Brisbane Road Carpark Redevelopment

Urban Design, Architectural &
CPTED Assessment Report

MCU 17/2169

RE: Final Urban Design, Architectural and CPTED Assessment of Brisbane Road Carpark Redevelopment, Mooloolaba - MCU 17/2169

Figure 2 Extent of carparking impacts on floor plates to provide inactive podium edges

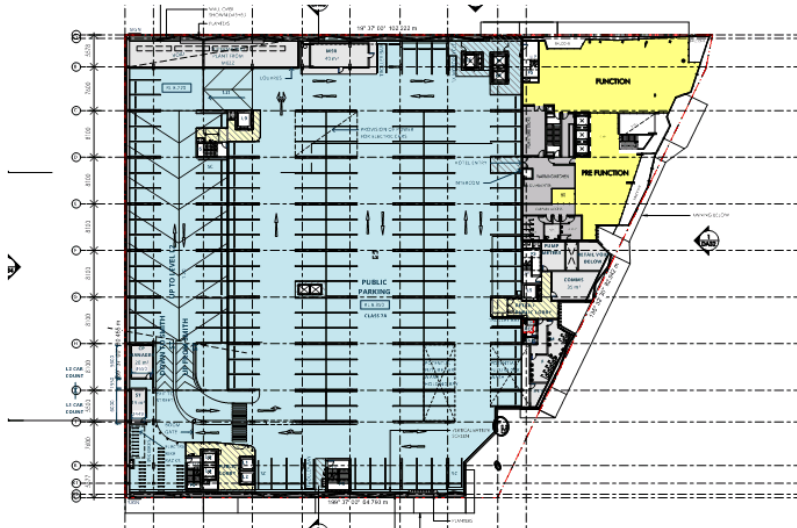
The extent of the supermarket means the basement car parking is not directly linked to the podium car parking by internal ramps. This is likely to cause confusion to those unfamiliar with the parking arrangements who enter from Brisbane Rd and expect to be able to circulate throughout to find a car park.

The mix of public parking, hotel, retail aged care and residential uses is uniquely complex within a regional setting but (as mentioned above) it is the scale of these uses places significant pressure on the design of the podium and the way it interacts with the street. The form of the podium is the most significant aspect of the built form. The need to achieve a specific target for car parking (approx 700 spaces), compromises the placement of lift and service cores. This in turn compromises street setbacks and ideal locations for pedestrian entry into the public car park. A total of 500 public car spaces would have eased pressure on the scheme and most likely allowed the podium and towers to have a better interface with the public realm.

Figure 3 Extent of retail limits connectivity and active edges to all streets

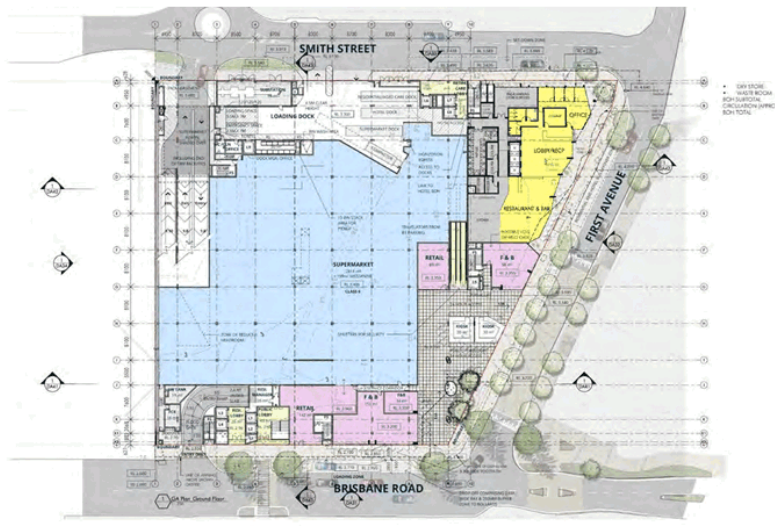
Two of the three towers are over 40m in length. These towers make a significant contribution to Brisbane Road and Smith Streets which should have a character of relaxed coastal urbanism. Assessment must ensure that they do not create a sense of over-crowding (when viewed from the street) or a perception of being too bulky and unnecessarily shading the street. This must

be balanced against the needs to achieve suitable orientation and amenity for the users. The design of the southern elevation of these towers and the way the length of the towers may be mitigated are important to this assessment. The degree of articulation through sun-shading and other applied treatments is also part of considerations.

Figure 5 Legible and convenient access to public uses

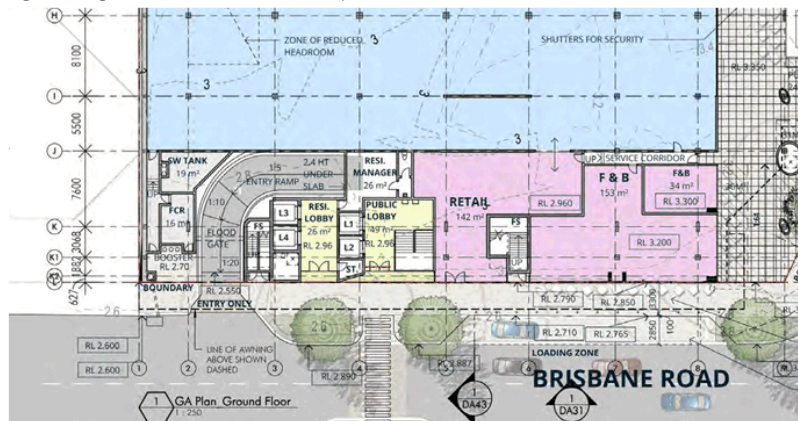
There has been ongoing dialogue with the applicants about the 'legibility' of access to the public car park and the ability of the public to navigate their way from key surrounding destinations using strong visual cues and without relying on signage, as required by the Mooloolaba Local Plan Code. This movement also must be visually open, allow 24/7 access, be safe and of a high amenity.

Figure 6 Sunshading and rain protection

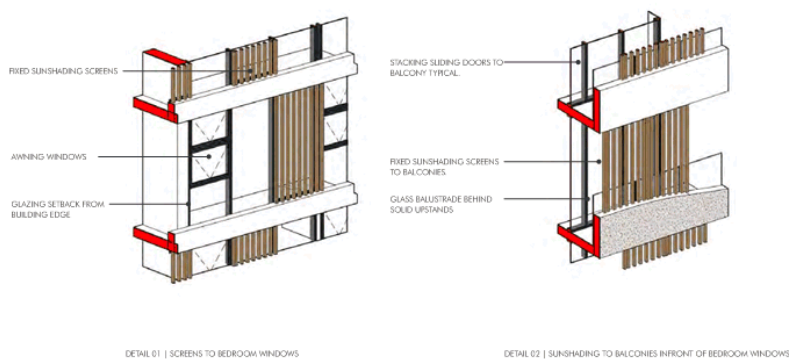
The proposed development must demonstrate an appropriate local climatic design response demonstrate a strategy to reduce the demand on non-renewable energy for cooling. Buildings with long east and west elevations require a specific strategy to exclude sun and rain impacts on rooms and private open spaces. This right design response can also positively influence the design character of the building. This assessment must also review how the building design minimises the production of greenhouse gas emissions particularly through the use of solar or other renewable energy systems.

Figure 7 Extent of sun penetration into the building

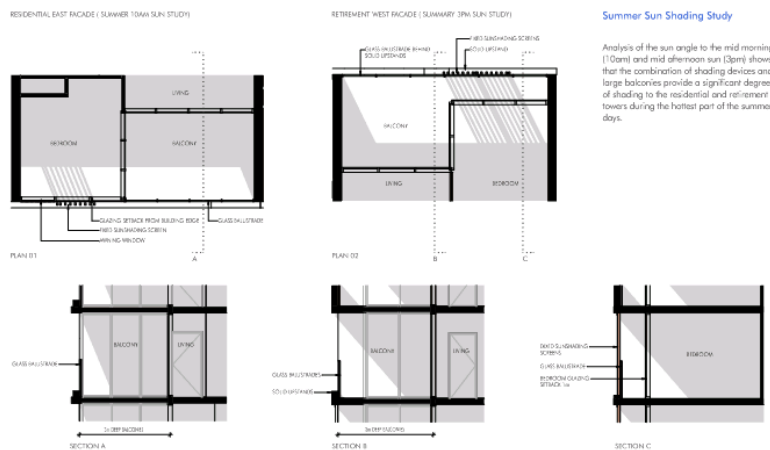
Development has been modified to include increased vertical screens and the Retirement Tower has a deeper recess in it. The proponents argument that it is effectively two components having an average length of 30m is not accurate, however the increased break in the elevation is acceptable.

The assertion that adequate sun-shading and window protection to all elevations in accordance with the Sustainable Design Code is not accepted. While some glazing elements have been pushed back and some windows have increased sun protection, the information provided does not demonstrate compliance. The revised drawings (refer Figure 7) clearly show summer morning and afternoon sun penetrating into habitable residential rooms. An assessment is made against the available material.

Figure 11 Carpark screening

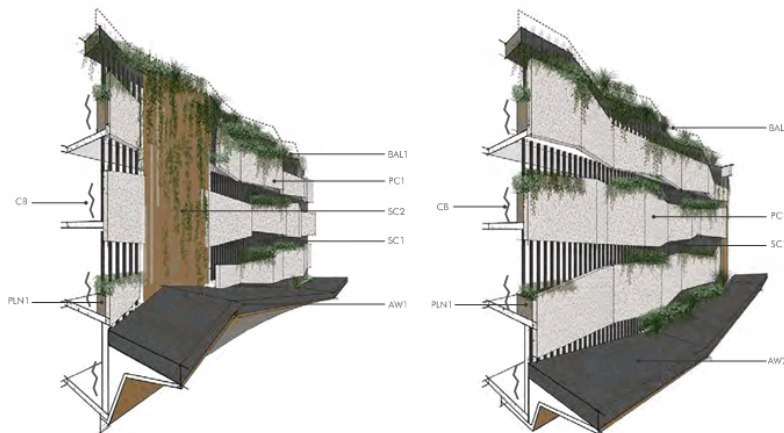
The impact the podium car parking has on the character of the streetscape is predominant design issue for the project. The key issue is the extent to which the podium screen mitigates the car parking uses and activates and energises the streetscape.

Due to the commercial requirements of project the proponents have elected to make only the upper levels of the podium active on First Avenue. The development uses an articulated screen with planters to the outside of the podium to shield the visual impact of the car park.

The proposed development issue here is assessed to have a sufficient level of visual amenity on Brisbane Road. The articulation, awnings and active ground level uses ensure that the car parking and vehicular access minimises the impact on the street and consistent with intended character of the streetscape.
